Permit of Authorization to Construct an On-Site Sewage Facility Permit Valid For One Year From Date Issued

Permit Number: 118728

644 GHOST DANCER

Attached is the revised design based on comments from the TCEQ Review.

Y. Site plan:

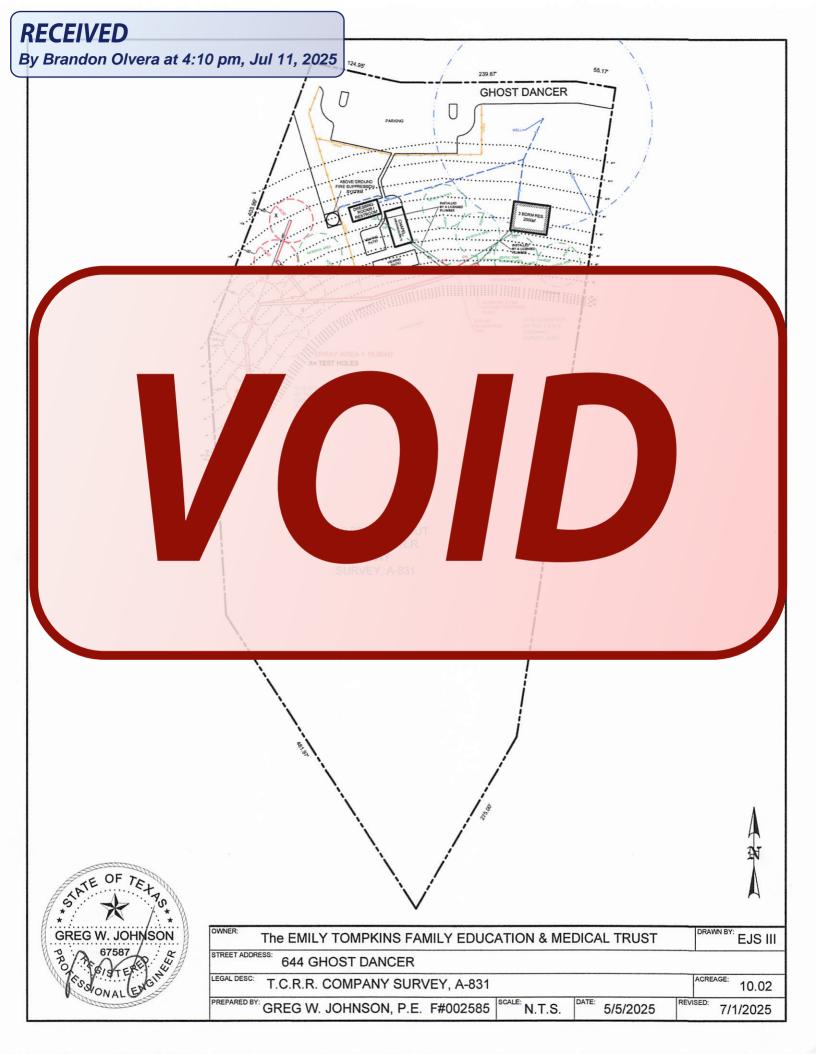
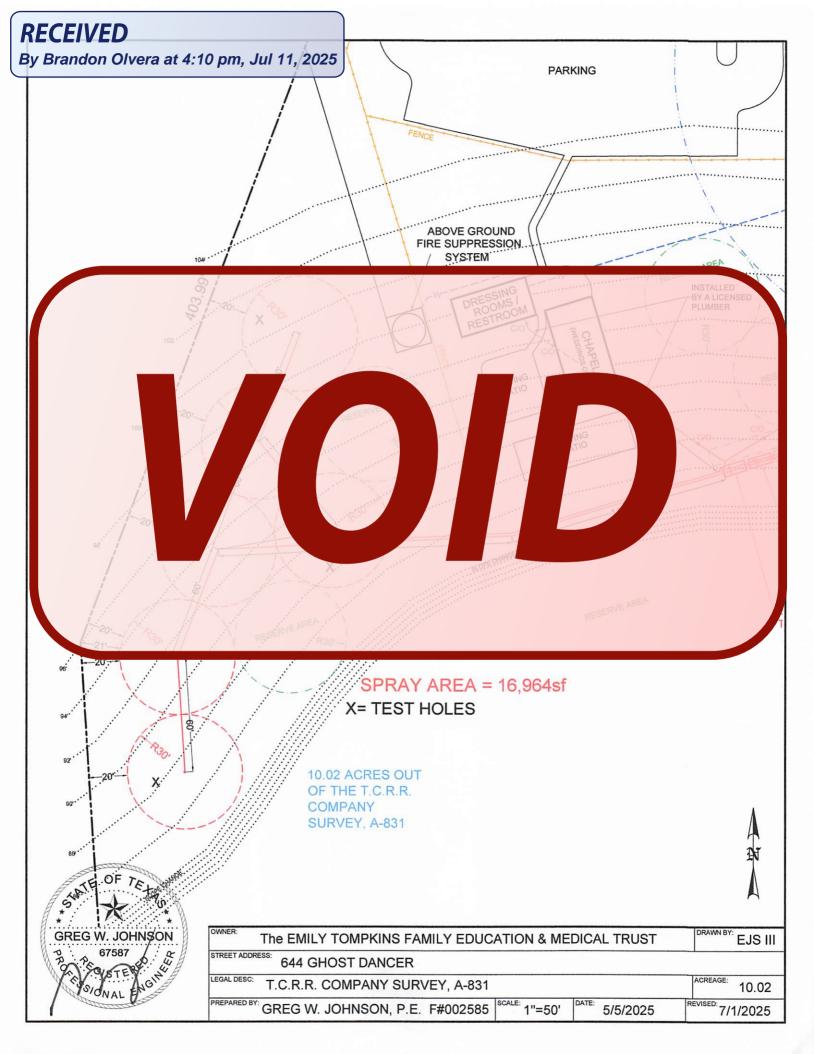
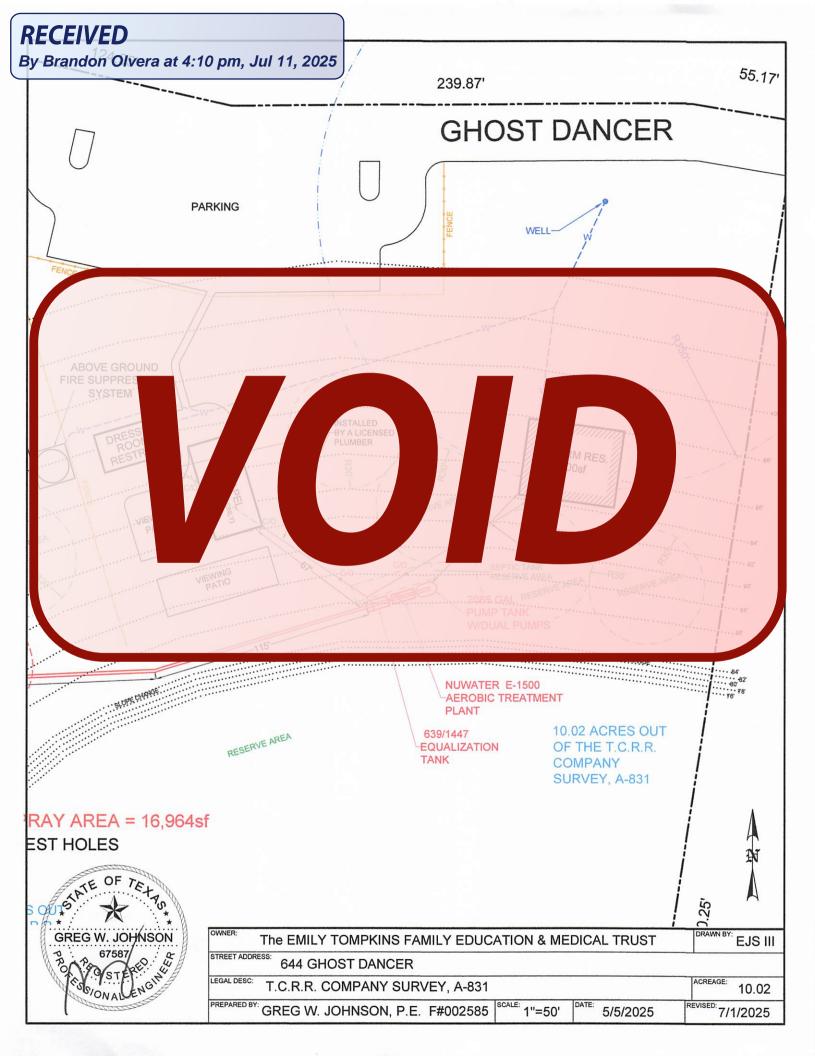
Show the radius for the spray areas marked as reserve.
